Southern Nuclear Operating Company
Vogtle Electric Generating Plant Units 3 and 4
Request for License Amendment:
Basemat Concrete/Rebar Details (LAR-12-007)

**Request for License Amendment
Regarding Basemat Concrete/Rebar Details
(LAR-12-007)**

**Licensing Basis Documents - Proposed Changes
(LAR-12-007)**

UFSAR Tier 2* Figure 3H.5-3 (Partial)

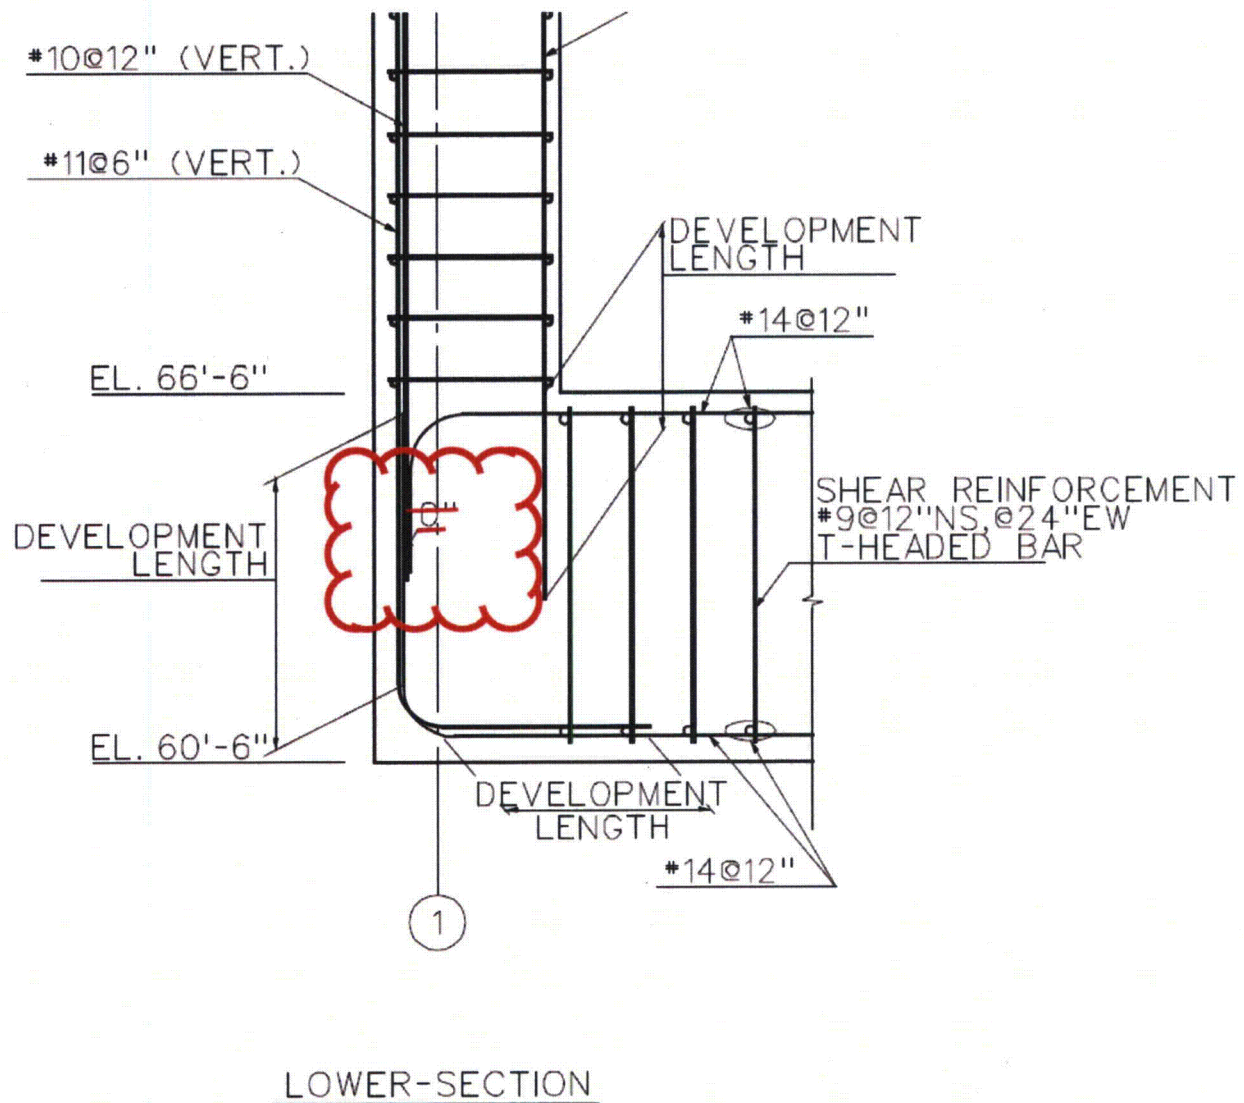
Rebar details: UFSAR Figure 3H.5-3 is revised to remove the 0" dimension in the portion of the figure showing the basemat below the wall. In the figure, the 0" dimension indicates that some of the vertical reinforcement will be in the same vertical plane. However, there is no text description of the application of this 0" dimension, nor of its purpose. Further, such information is not a key design feature nor is it considered in the analyses. This dimension is removed for the Vogtle design as the hook tails are not aligned in the same vertical plane.

Revise Figure 3H.5-3 as described and shown below.

In the Lower-Section detail of Figure 3H.5-3 that represents the basemat below the exterior wall, the 0" dimension is removed.
